NORTHEAST UTILITIES

March 23, 1984

Millstone Nuclear Power Station, Unit 3
NRC Chemical Engineering Branch (Fire Protection)
Review Meeting, March 7, 1984

Status of the NRC-CMEB (Fire Protection)
Draft SER Open Items Discussed at the Meeting
with the NRC-CMEB March 7, 1984

FIRE BOUNDARY DRAWINGS

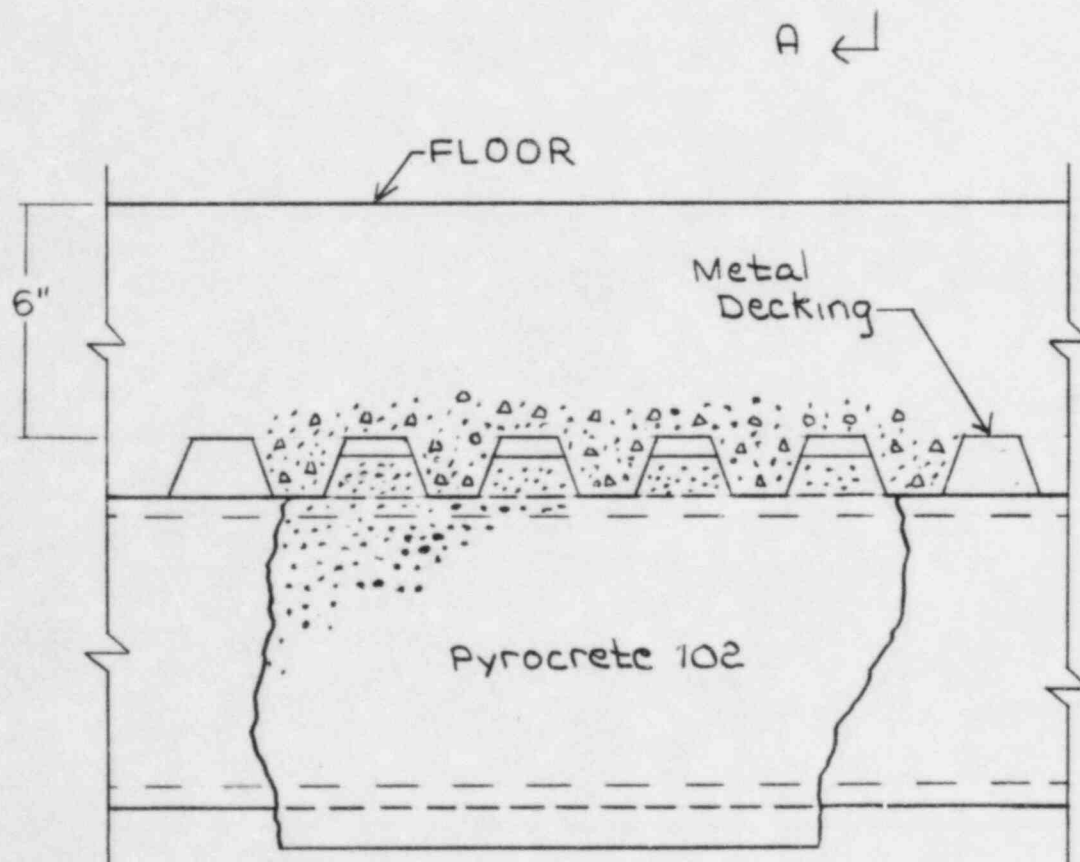
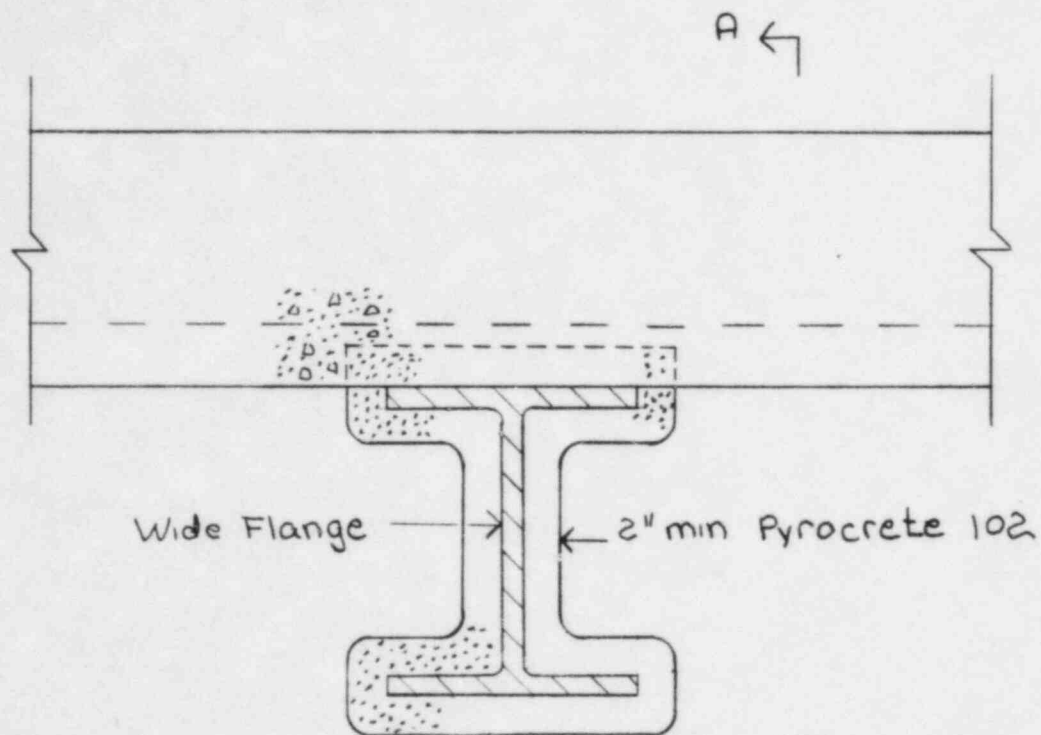
The walls that separate buildings and walls and floor/ceiling assemblies used to enclose rooms containing safe shutdown systems are 3-hour-fire-rated. However, the applicant has not indicated all fire rated assemblies are tested in accordance with ASTM E-119, "Fire Tests of Building Construction and Materials." To assure that all fire rated assemblies will perform as indicated under fire conditions, we will require the applicant to verify that all assemblies have been tested in accordance with ASTM E-119. This is an open item.

It should be noted that only those fire barriers constructed to provide the necessary separation to assure safe shutdown, as highlighted on the fire boundary drawings (S&W Nos. 12179-EM-60A-2 through 60D-2) contained in Attachment A, have been included in NNECO's review. Additional types of fire resistant construction have been utilized throughout the plant, as indicated on the fire boundary drawings, in order to subdivide the larger fire areas into fire zones. These fire barrier assemblies have not been specifically designed to meet the stated criteria and as such have not been considered in this review.

SWITCHGEAR AREAS, TUNNELS, AND CURBING

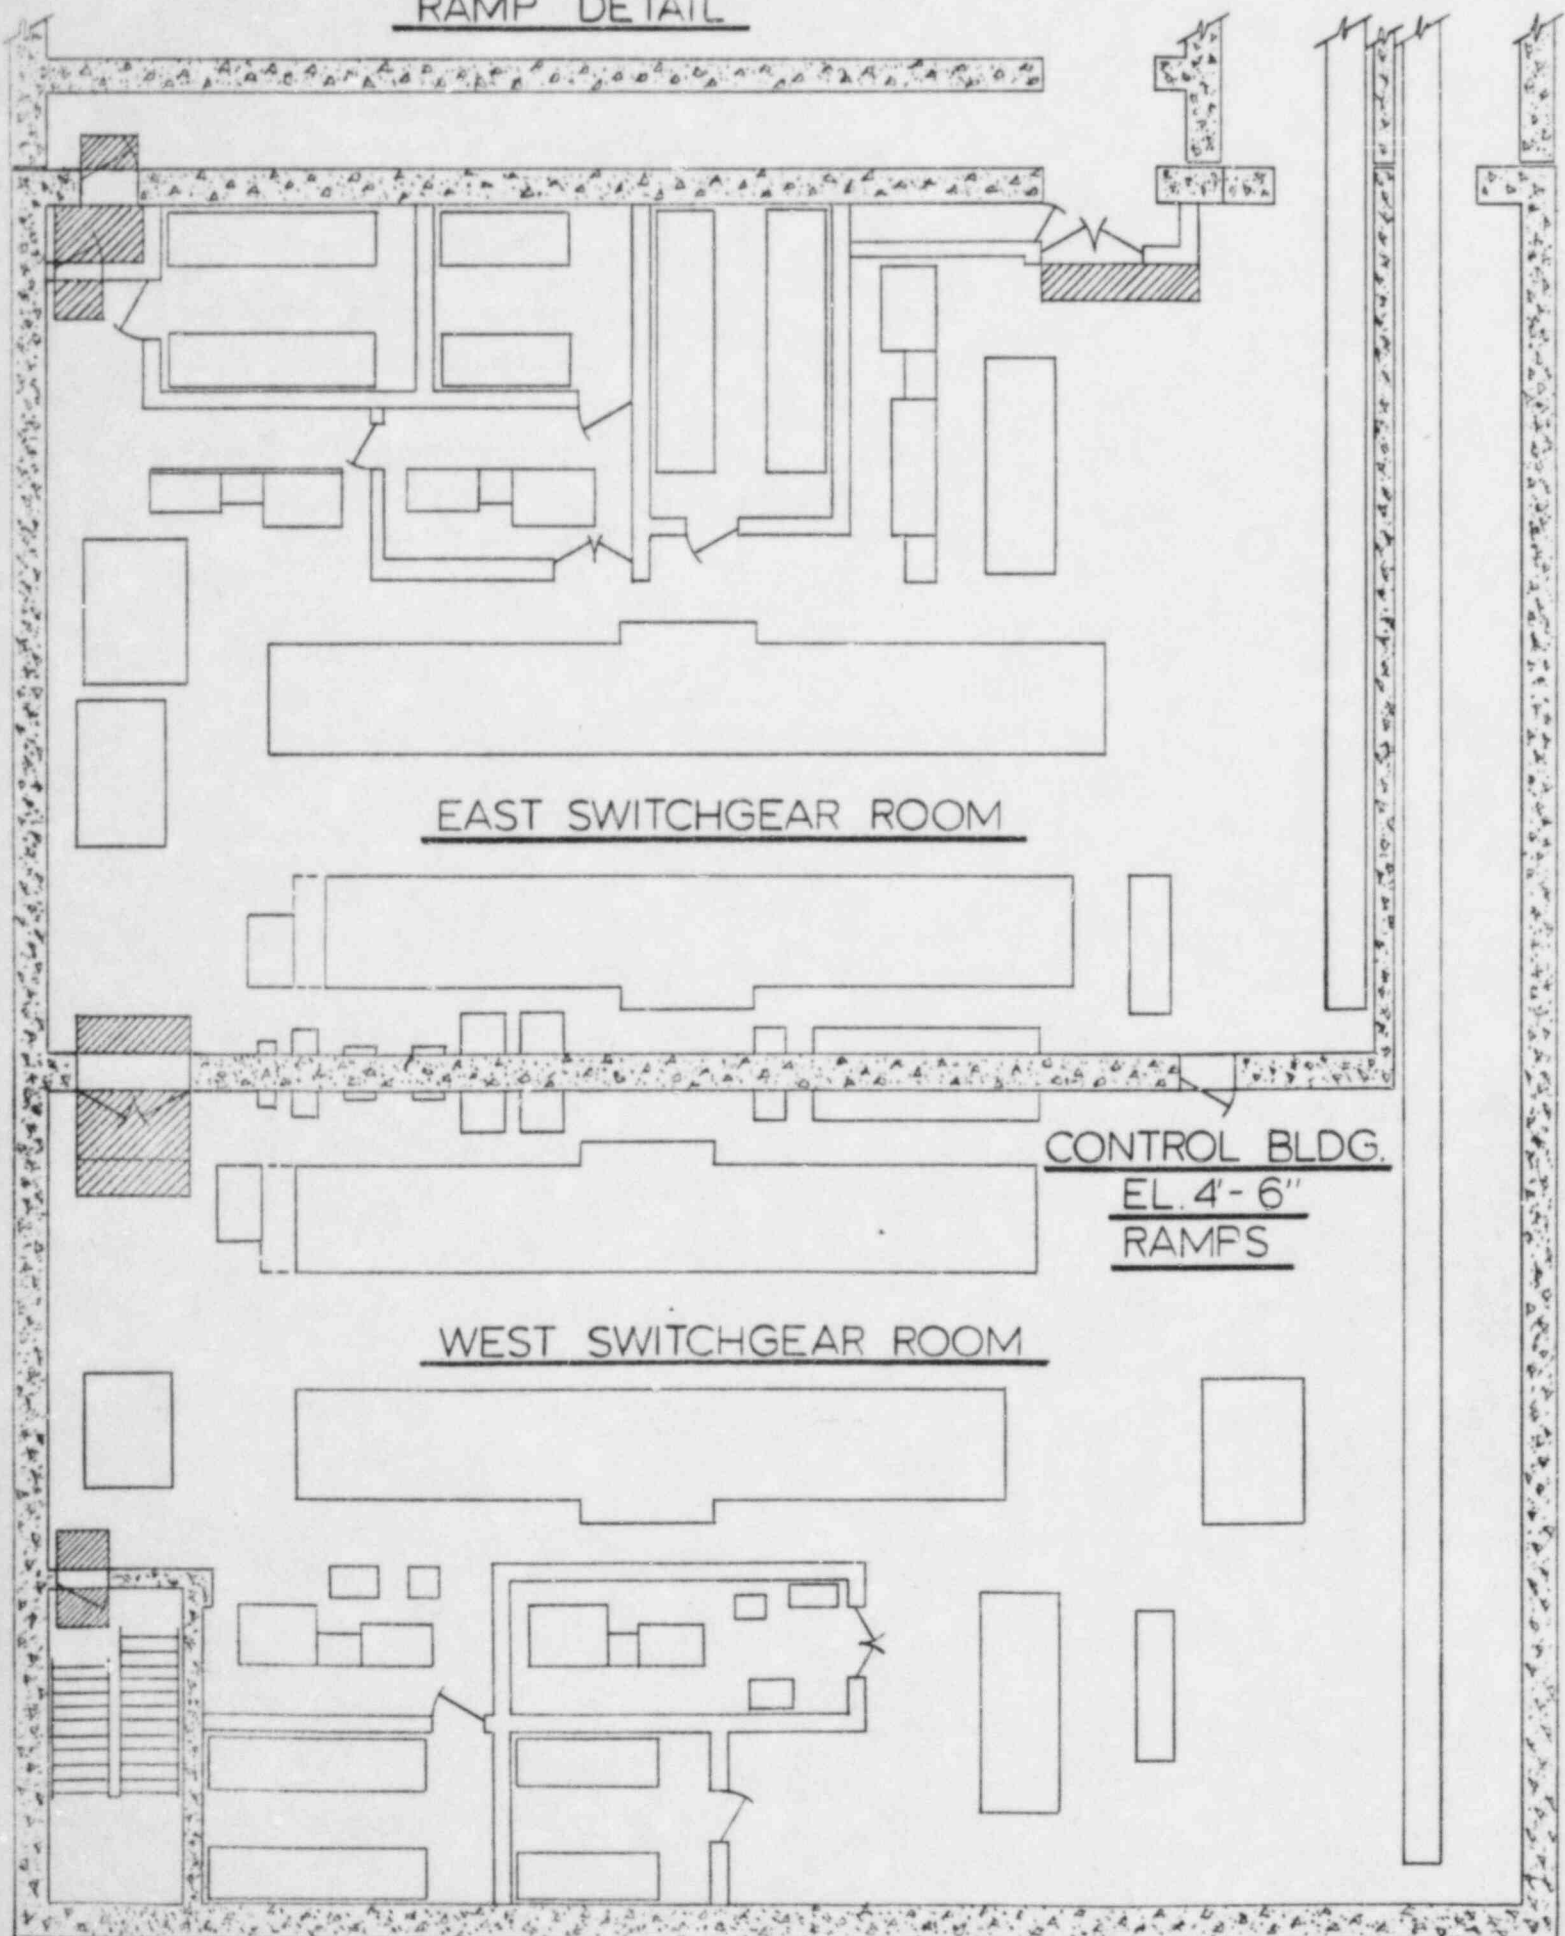
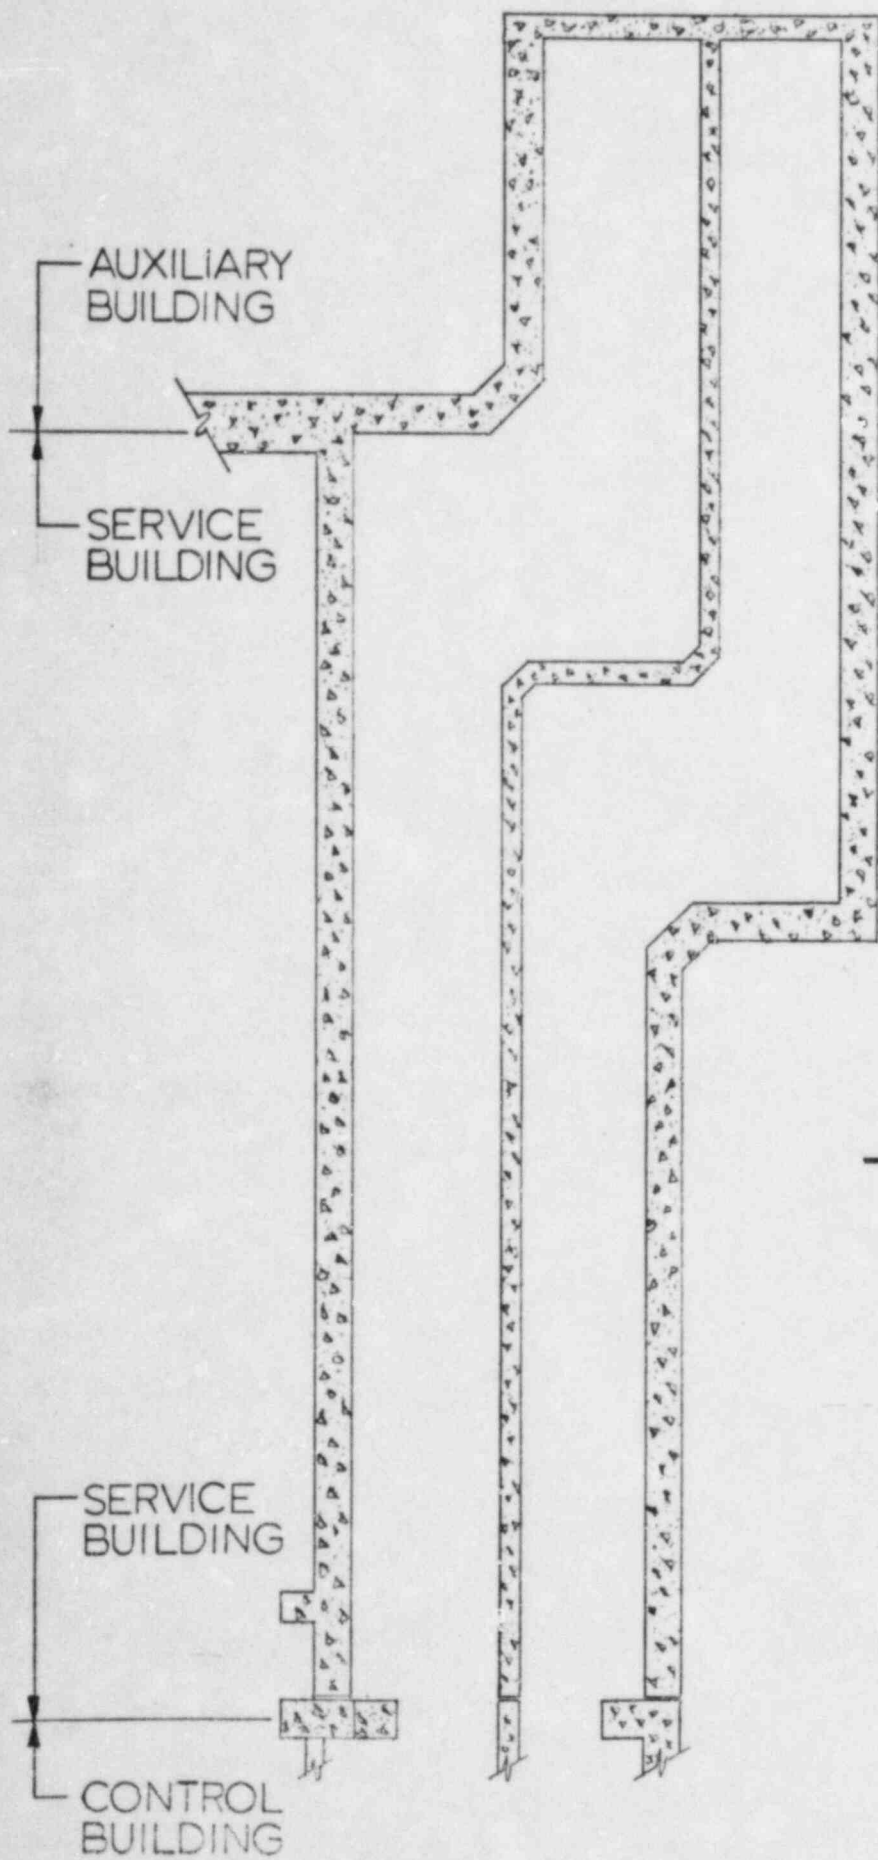
Floor drains have not been provided in the switchgear rooms to prevent damage to equipment from fire fighting water. We will require the applicant to provide floor drains to meet the guidelines of BTP CMEB 9.5-1, Section C.7.e. This is an open item.

switchgear areas and surrounding adjacent areas, as illustrated in the sketches contained in Attachment A. This curbing is sufficiently sized to contain the discharge from two 1½" hand hose lines (60 gpm per hose line) for approximately 129 minutes within either switchgear area; see Attachment B for calculations. This will provide an additional 30 minutes of water discharge beyond the assumed maximum fire duration of 99 minutes for these areas as calculated in the "Fire Protection Evaluation Report" (Attachment C). Also any minor water accumulation (less than 2") in the redundant switchgear area would not affect the operation of the switchgear equipment. This is based upon a minimum three inch clearance that is maintained within the switchgear cabinets between the floor and any switchgear equipment/cabling.

Sketch 1

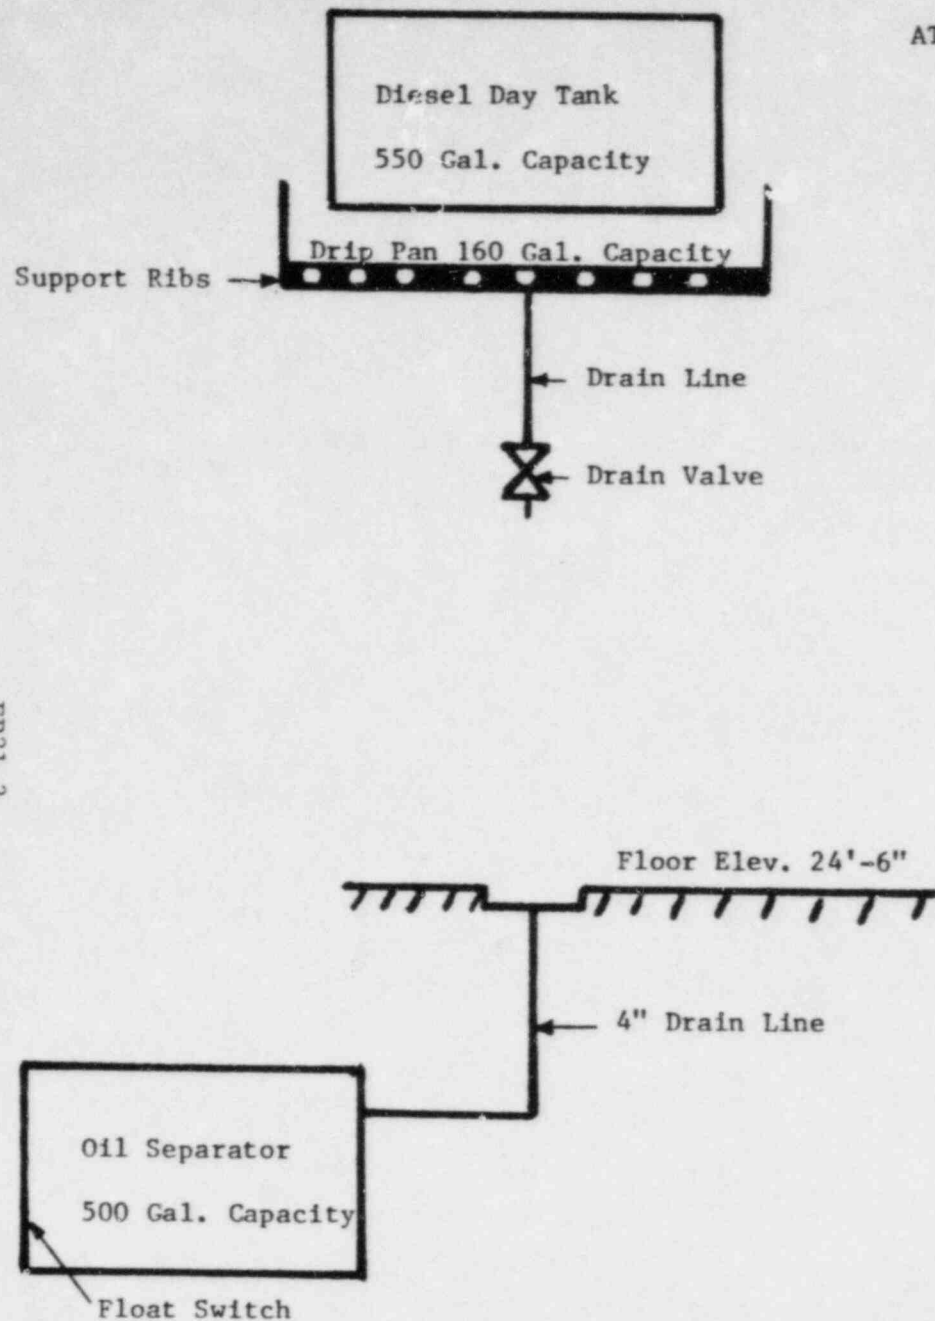
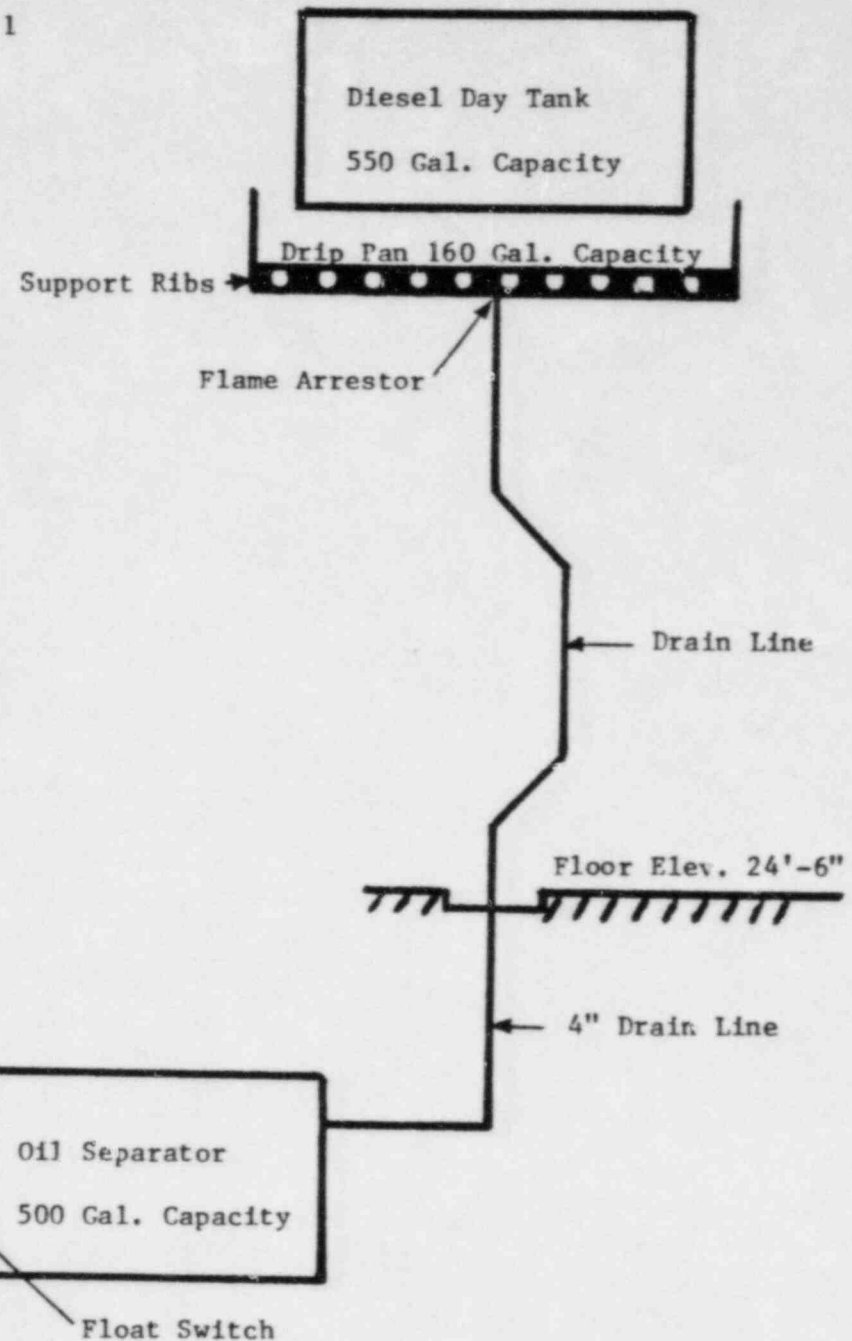
Both diesel generator/day tank areas are completely redundant and physically separated from each other and from other areas of the plant by fire barriers having a minimum fire resistance rating of three hours. A dip pan design capable of holding 160 gallons of fuel for each day tank is provided for both areas. A preaction sprinkler system, activated by heat detectors, is also provided for each area. In addition, ultra violet (UV) fire detectors are installed to provide both a local alarm and annunciation in the control room. Fire hose stations, portable fire extinguishers, and a yard hydrant fire protection system are all available for backup manual protection. Floor drains connected to an oil separator located outside of the area allow for adequate drainage in both areas (See existing design attachment I, sketch I).

Although sufficient justification exists to assure that safe shutdown can be achieved, NNECO proposes to modify the existing (Attachment I, Sketch I) fuel collection system to provide a positive means of collecting/ drainage/fuel oil (See Attachment I, Sketch II). The proposed collection system will be hard piped to an underground storage oil separator tank and the total capacity of this collection/drainage system will contain 110% of the day tank capacity. NNECO trusts that this proposed collection/drainage system concept will satisfy the fire protection concerns for the Diesel Generator Rooms.
